EL PASO COUNTY • COUNTY HEALTH DEPARTMENT

TO CONSTRUCT, ALTER, REPAIR or MODIFY ANY INDIVIDUAL SEWAGE DISPOSAL SYSTEM

Issued To HEYDEN DEVEL. CORP.Date 7-24-92Address of Property 9550 BENNISON TERRACE, LOT 5Phone 495-0630

Re: Septic System Installation  
9550 Bennison Terrace  
Lot 5, Raygor Subdivision  
El Paso County, Colorado

ABSORPTION FIELD  
LOCATION PLAN

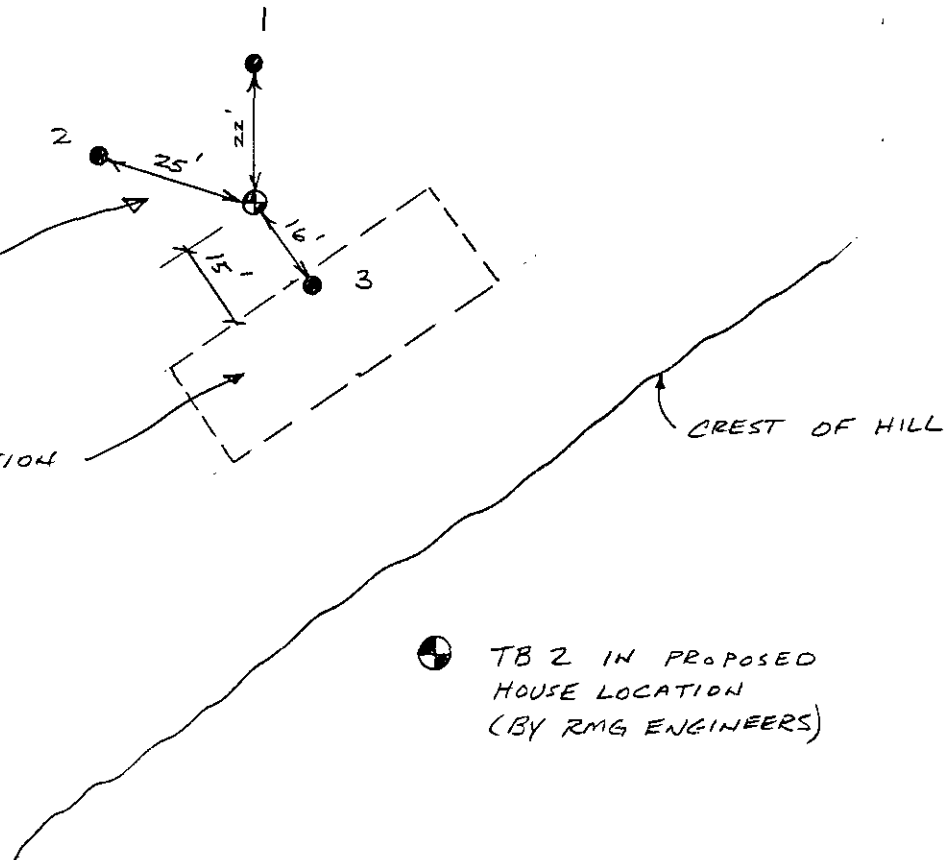
Due to the presence of groundwater within 4 feet of the ground surface, it is our recommendation that the absorption field be moved upslope from the profile hole approximately 15 feet. See Figure 1 for proposed location of absorption field. Due to the variable percolation rate shown on the report by RMG Engineers, it is our recommendation that the absorption field be sized based on a percolation rate of 40 minutes/inch. The absorption field at a percolation rate of 40 minutes/inch should be sized to 285 square feet per bedroom. It is our understanding that the structure at the above referenced site will have 4 bedrooms. With a 4 bedroom house, the absorption field should be sized to 1140 square feet. The absorption field should consist of a gravel bed 24 feet wide by 48 feet in length. (See Figure 2.) An alternative to the gravel bed would be the installation of infiltrators. With a reduction of approximately 21 percent, the absorption field may consist of 6 rows of 8 infiltrators. Due to the slope, the infiltrators may be placed parallel to the slope and stepped down the slope. A distribution box would be required to properly distribute the effluent to the individual rows of infiltrators.

# ABSORPTION FIELD CROSS SECTION

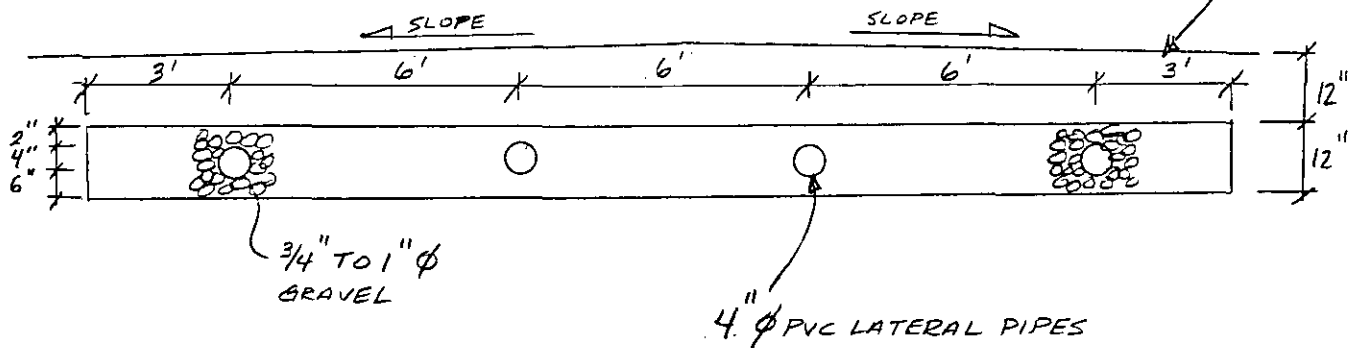
SLOPE GROUND SURFACE  
IN AREA OF ABSORPTION  
FIELD TO ALLOW WATER  
TO FLOW AWAY FROM  
ABSORPTION FIELD.

PROVIDE ADDITIONAL SOIL  
AND MOUND OVER  
ABSORPTION FIELD.

6 ROWS OF 8 INFILTRATORS  
MAY BE USED IN PLACE OF  
THE GRAVEL BED.
